**9.2 NO. 193 (LOT: 153; D/P 98699) LAKE STREET, PERTH - PROPOSED ALTERATIONS AND ADDITIONS TO SINGLE HOUSE**

The purpose of this report is to consider an application for development approval for Alterations and Additions to Single House at No. 193 Lake Street, Perth (the subject site) that is included on the City of Vincent Heritage List as Management Category B – Conservation Recommended.

*Development Application*  
REAR ADDITION PLAN, ELEVATIONS, SECTION

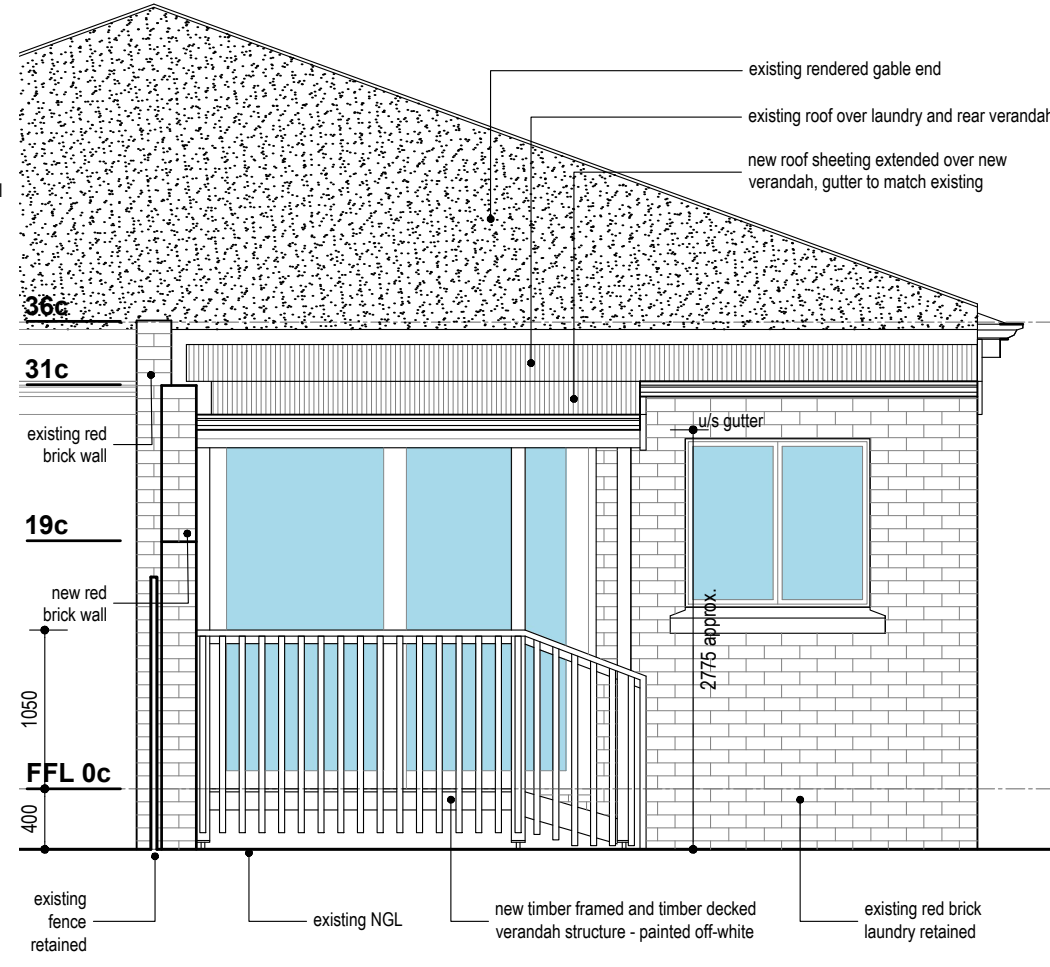
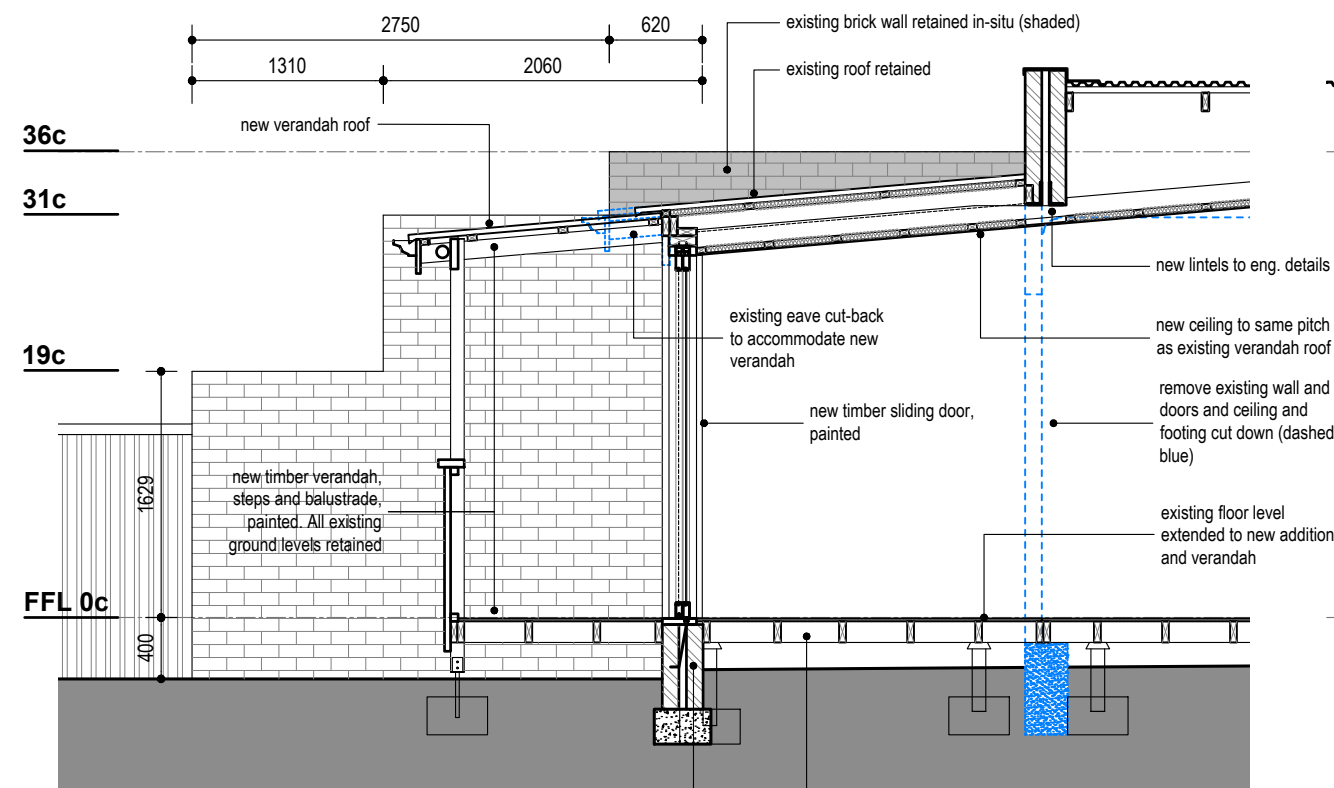
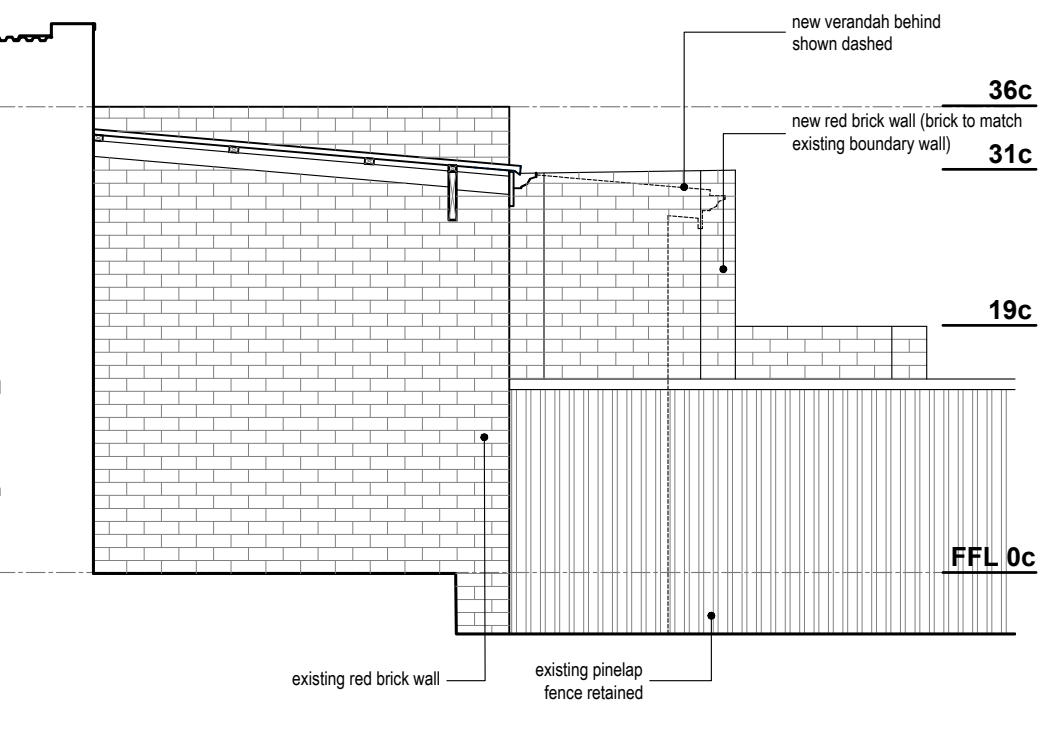
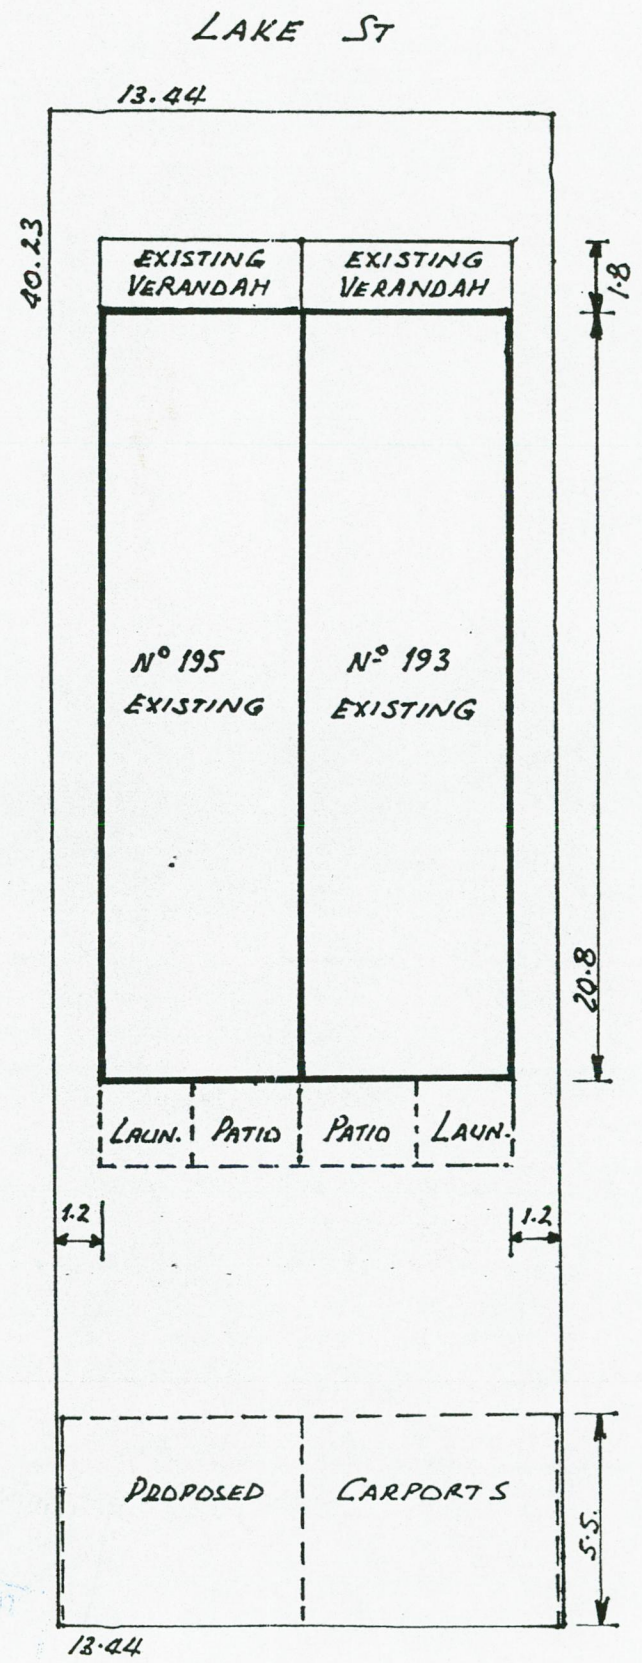
Boundary Wall	
Deemed-to-Comply Standard	Proposal
<b>R Codes Volume 1 Clause 5.1.3</b>  <u>Northern boundary:</u>  Permitted boundary wall length: 24.2 metres.	<u>Northern boundary:</u>  Proposed boundary wall length: 28.05 metres. (additional 2.75 metre length proposed).

- The proposed boundary wall extension is of an acceptable height and uses high-quality materials to reduce building bulk impacts to the neighbouring property. The location of the boundary wall would not result in overshadowing of adjoining properties and enhances the sense of privacy between the two sites.

The proposed boundary wall to the northern lot boundary would satisfy the design principles of the [R Codes](#) and the local housing objectives of the [Built Form Policy](#) for Lot Boundary Setback for the following reasons:

- **Reduced Building Bulk:** The building bulk presented to the adjoining property would be minimal as the subject site has an existing 25.3 metre-long boundary wall constructed adjacent to an adjoining boundary wall of the same length and height at No. 195 Lake Street. The proposal seeks to extend the existing boundary wall length by 2.75 metres, with 1.5 metres of this length provided at a height of 3.1 metres and the remaining 1.25 metres stepping down to a maximum height of 2.0 metres. The height of the proposed boundary wall sits below the permitted deemed-to-comply height of 3.5 metres, reducing visual impacts to the northern property. The boundary wall would be constructed of single course face brick to match the existing boundary wall materiality, which would provide textural interest and reduce the visual impact of the wall. The combination of the short length of wall that would be visible, stepped height and proposed finish would minimise the presentation of bulk to the adjoining property and was supported by the City's DRP member.

- **No Overshadowing or Impact to Ventilation:** The boundary wall is located to the northern boundary of the site and would not adversely impact the adjoining property's access to direct sun or ventilation as its shadow would fall within the subject site. Areas to the west of the boundary wall include open garden area, allowing ventilation to flow between the two outdoor living areas.

- **Effective use of space:** Due to the narrow 6.7 metre-wide lot, the location of the proposed boundary wall assists in maximising the subject site internal dining space and outdoor living area. The boundary wall would facilitate the effective use of outdoor living area by providing for visual privacy and minimising overlooking between the subject site and adjoining property.

- **Heritage Demolition:** The Heritage Management Policy accepts partial demolition to heritage listed places where the parts to be demolished do not contribute to the cultural heritage significance of the place. The proposed demolition relates to the 1996 extension to the rear of the house which does not contribute to the site's cultural heritage significance regarding the Federation Free Classical presentation to Lake Street, which would be retained.

- **Compatibility with Existing Fabric:** The Heritage Management Policy seeks for alterations and additions to be respectful of existing fabric and to be readily identifiable as 'new work'. The colours and materials of the proposed additions include single course red brickwork, plaster, timber, and white paint, which would be complimentary to the colours and materials that exist within the heritage fabric of the place. The proposal's materials and finishes does not mimic or replicate historic styles and would not obscure the heritage fabric of the house due to its location at the rear of the existing house. The additions can be distinguished as 'new work' because they are attached to the 1996 extension and not the portion of the house constructed in 1908. The proposed roof over the verandah and dining room is an extension to the 1996 skillion roof which is a distinctly different style from the original gabled roof that covers the subject site and No. 195 Lake Street.

This approval is for Alterations and Additions to Single House as shown on the approved plans dated 14 November 2023. No other development forms part of this approval;

The surface finish of boundary walls facing an adjoining property shall be of a good and clean condition, prior to the practical completion of the development, and thereafter maintained. The finish of the boundary walls is to be face brick, or material as otherwise approved; to the satisfaction of the City; and
